The Commission has issued the enclosed Amendment No. 94 to Facility Operating License No. DPR-46 for the Cooper Nuclear Station. This amendment consists of changes to the Technical Specifications in response to your application dated September 20, 1985, as supplemented by letter dated September 23, 1985.

The amendment revises the Technical Specifications to incorporate changes to (1) permit reactor operation with one recirculation loop out of service, (2) provide for detection and suppression of thermal-hydraulic instabilities during both dual loop and single loop operation, and (3) update some references and delete some blank pages.

NEBRASKA PUBLIC POWER DISTRICT
DOCKET NO. 50-298
COOPER NUCLEAR STATION
AMENDMENT TO FACILITY OPERATING LICENSE

Amendment No. 94
License No. DPR-46

FIGURE 3.3.1.

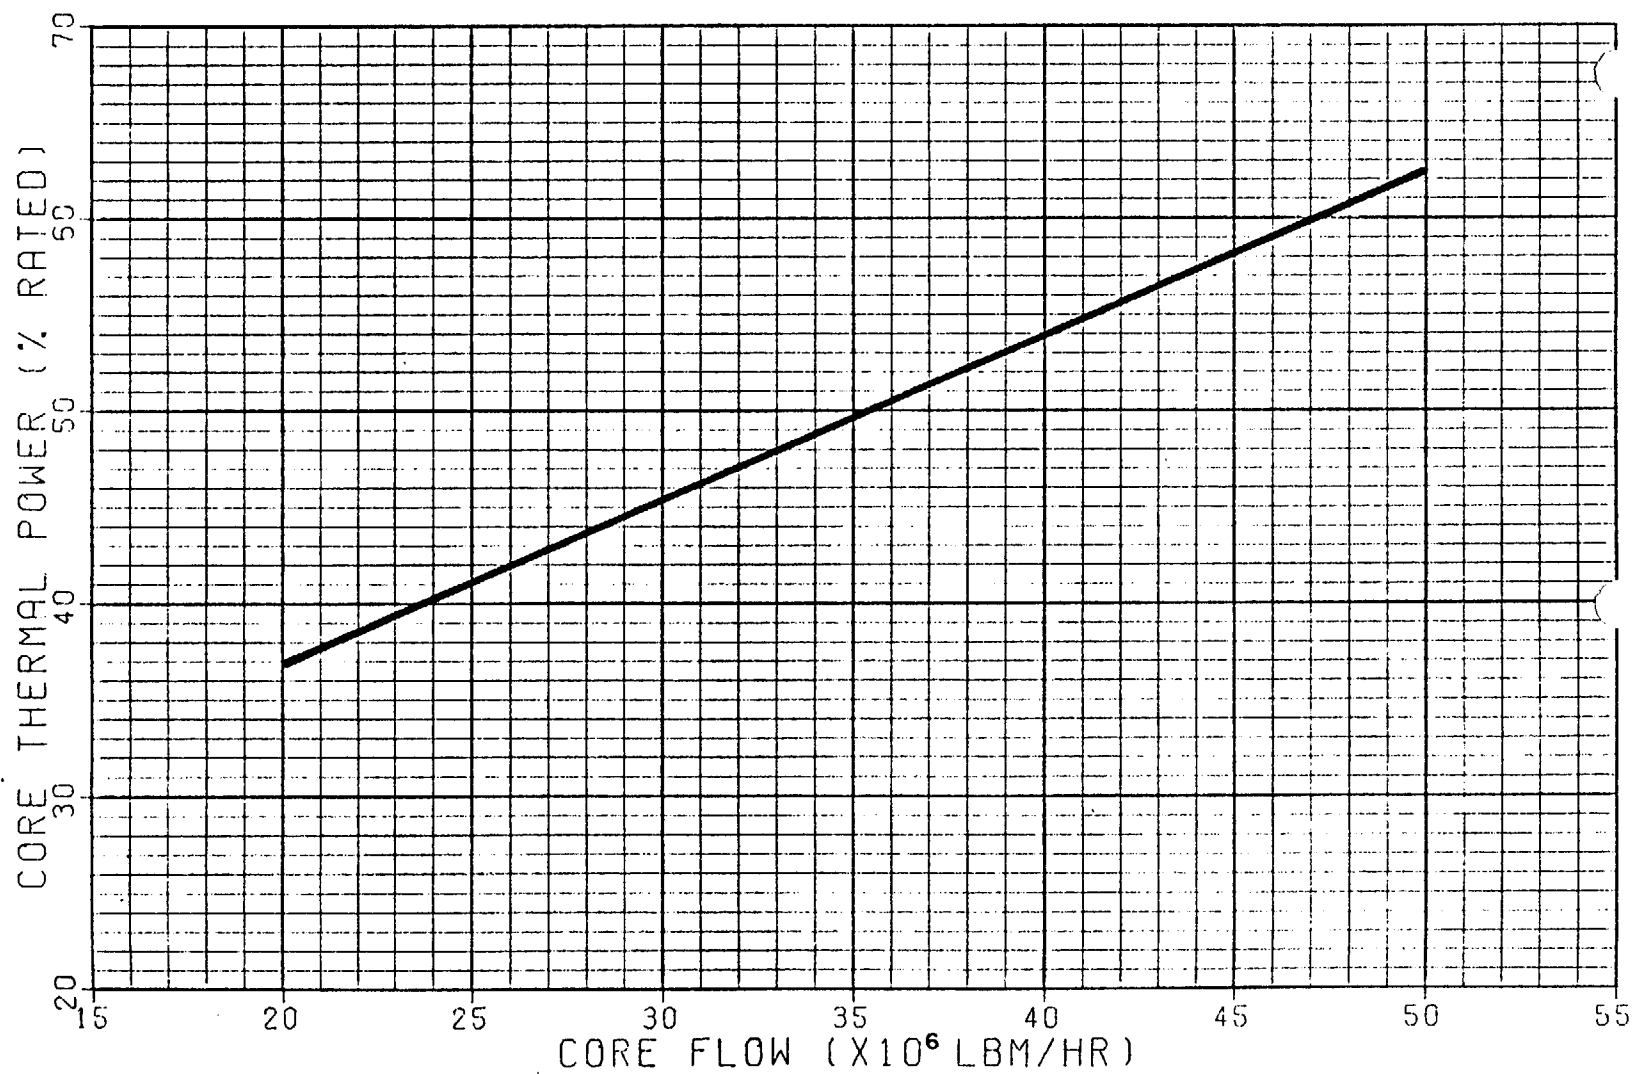
1. A recirculation pump shall not be started while the reactor is in natural circulation flow and reactor power is greater than 1% of rated thermal power.
2. With two recirculation pumps in operation and with core thermal power greater than the limit specified in Figure 3.3.1 and total core flow less than 45% of rated, the APRM and LPRM* neutron flux noise levels shall be determined within 2 hours, and:
 - a) if the APRM and LPRM* neutron flux noise levels are less than or equal to three times their established baseline levels, continue to determine the noise levels at least once per 8 hours and also within 30 minutes after the completion of a core thermal power increase of at least 5% of rated core thermal power while operating in this region of the power/flow map, or

1. With two recirculation pumps in operation and with core thermal power greater than the limit specified in Figure 3.3.1 and total core flow less than 45% of rated, establish baseline APRM and LPRM* neutron flux noise levels within 2 hours, provided that baseline values have not been previously established since the last core refueling.

2.
 - a) Prior to operation with one recirculation pump not in operation and core thermal power greater than the limit specified in Figure 3.3.1 establish baseline APRM and LPRM* neutron flux noise levels, provided that baseline values have not been previously established since the last core refueling. Baseline values shall be established with one recirculation pump not in operation and core thermal power less than or equal to the limit specified in Figure 3.3.1.

3. The reactor may be started and operated, or operation may continue with one recirculation loop not in operation provided that;
 - a. with one recirculation pump not in operation and core thermal power greater than the limit specified in Figure 3.3.1, core flow must be greater than or equal to 45% of rated, and

- (i) the Surveillance Requirements of 4.3.F.2.a have not been satisfied, immediately initiate action to reduce core thermal power to less than or equal to the limit specified in Figure 3.3.1 within 4 hours, or
